### ELECTRICAL SAFETY INSPECTION REPORT FORM

Building: Plaza South

Address: 4280 Galt Ocean Dr, Ft Lauderdale Fl 33308

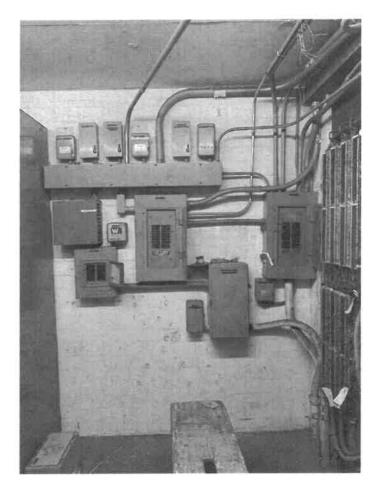
Main service disconnects for apartments meter centers are under a sanitary drain. Disconnects must be protected with an aluminum lid (pan) from leaks.

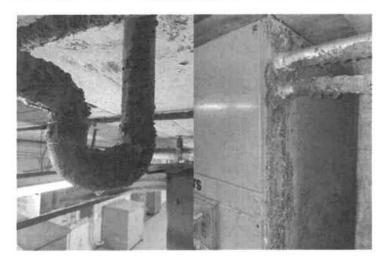
Open knock outs must be covered with a listed cover. Switch must be removed. Branch circuits must be identified on placard.

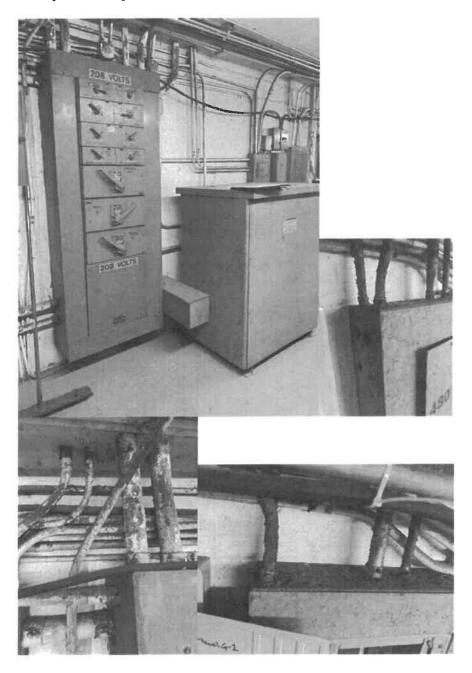
Main electrical room switch gear has severe corrosion due to plumbing leacks. Pan (lid) must be provided with drain over electrical equipment.

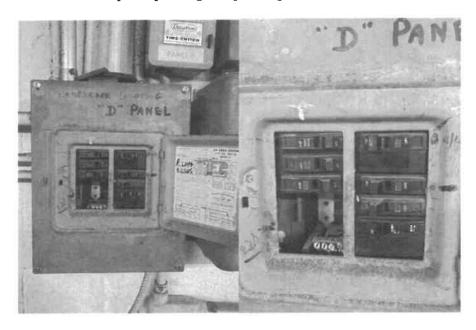
Conduits have severe corrosion that must be removed. Conduits must prime and painted. If the conduits are perforated, they must be replaced. 480v panel has open knock outs and severe corrotion.

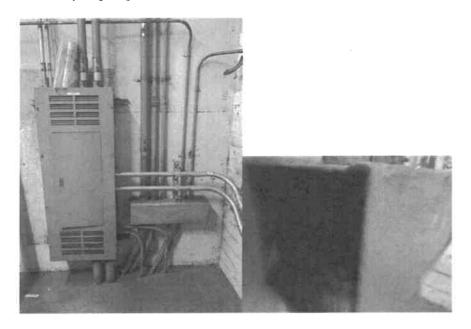
Panel D has open breaker position that must be covered with a UL listed cover. Panel requires priming and painting.

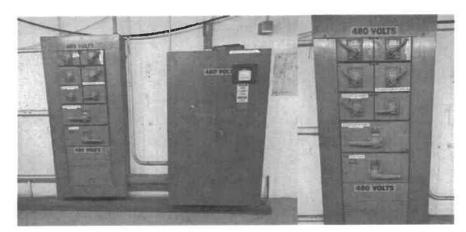
Wire way in pump room is missing end cover.

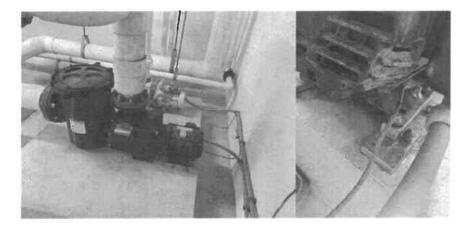
Building booster pump (top right disconnect) cannot be connected to the emergency panel. Must be relocated to a normal power panel.

Fire pump feeder cannot have over current protection.

Emergency generator is rated for 175 KW/219 KVA at 3 ph, seems underrated for 75 hp fire pump and emergency load. Recommend doing a load study and load test with fire pump under load on emergency power.

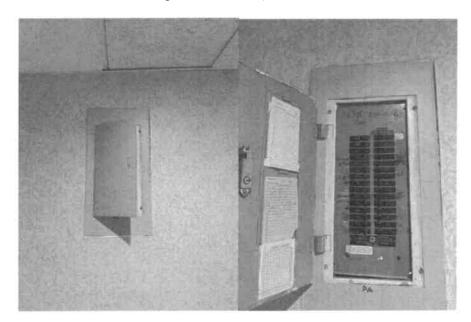
Pool bond must be tested to be connected to all metallic ladders and fixtures in contact with the pool water.

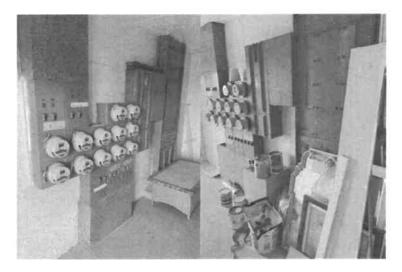
Corridor building panels must be under management control. Recommended installing a lock with key on all corridor panels.

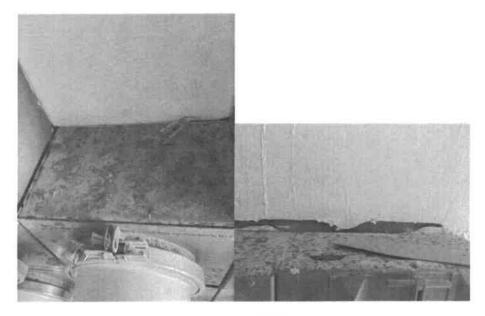
No storage is permitted in electrical rooms.

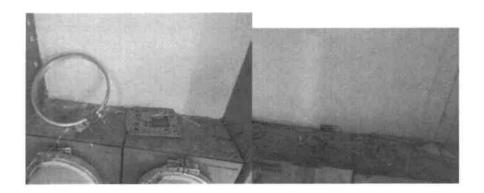
Tennant meter centers require rust to be removed and prime and painted.

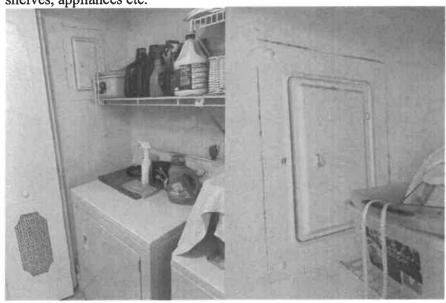
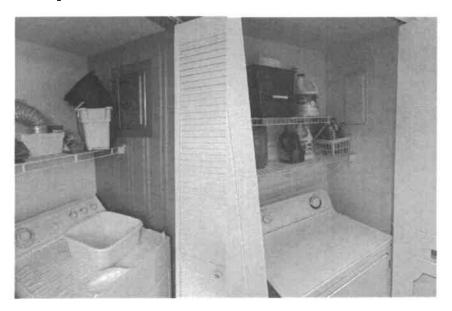
Unit electrical panels must be readily available, cannot be blocked by

shelves, appliances etc.

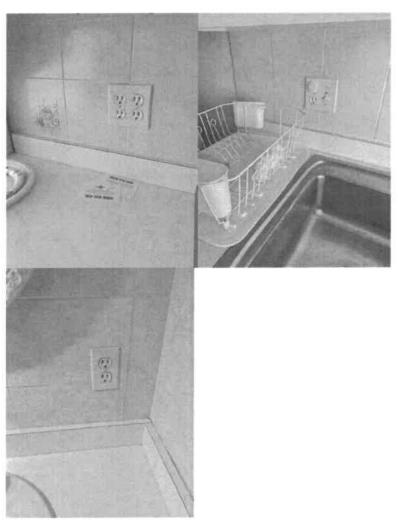
Kitchen and bathroom receptacles must be GFCI type.
